PRODUCT: MediaWall® V 4K/UHD DISPLAY PROCESSOR
TITLE: VERSION 1.1.0.0 RELEASE NOTES

DATE: 24 JULY 2015

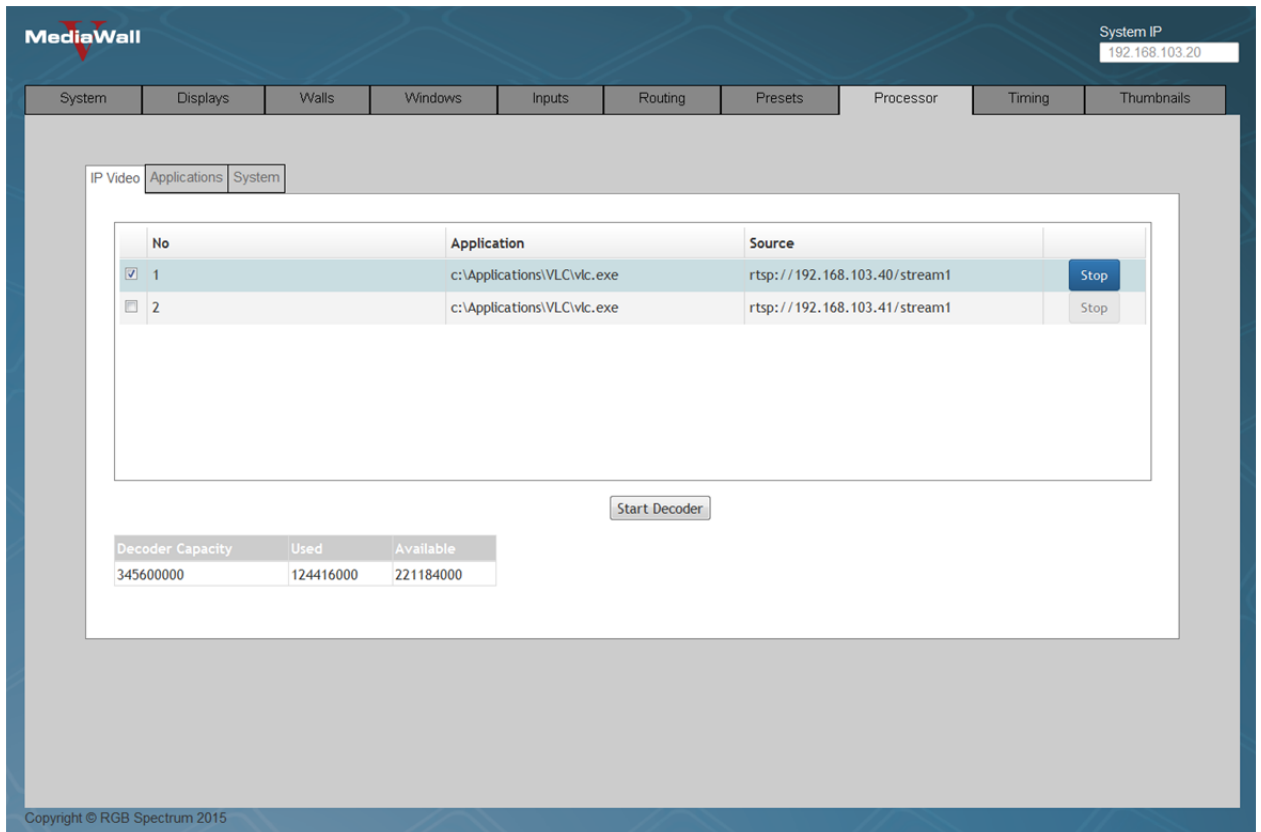
- **Application Processor (AP) Support:** You can now use the *MediaWall V* Web Interface to control the AP in a *MediaWall V 500AP-4K*. The web interface provides controls for starting and stopping IP video streams, displaying documents, and for restarting the AP itself.

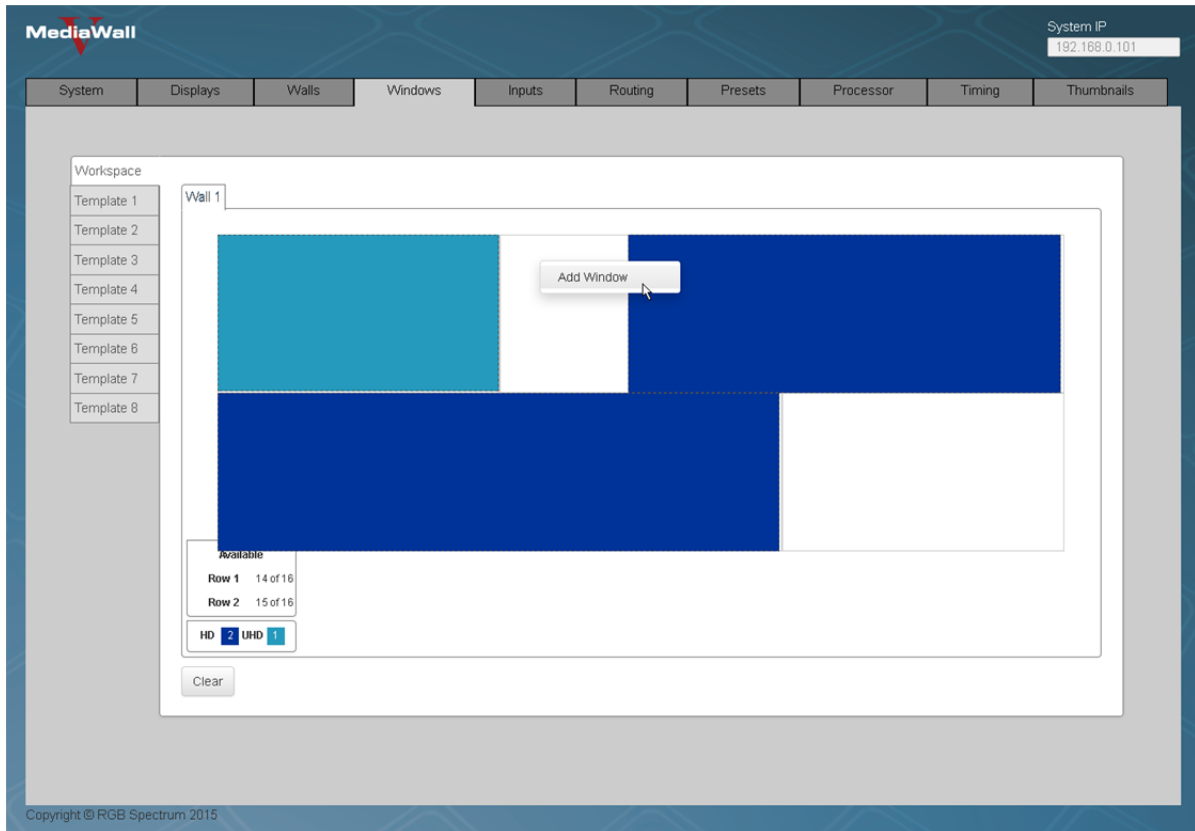
- **Custom Window Layouts:** You can now use the *MediaWall V* Web Interface to create custom window layouts. You can either start from an empty wall with no windows, or load a predefined layout template. You can then customize this layout as needed – deleting or adding windows and specifying their size, position, and type – and save it in a preset for later recall.
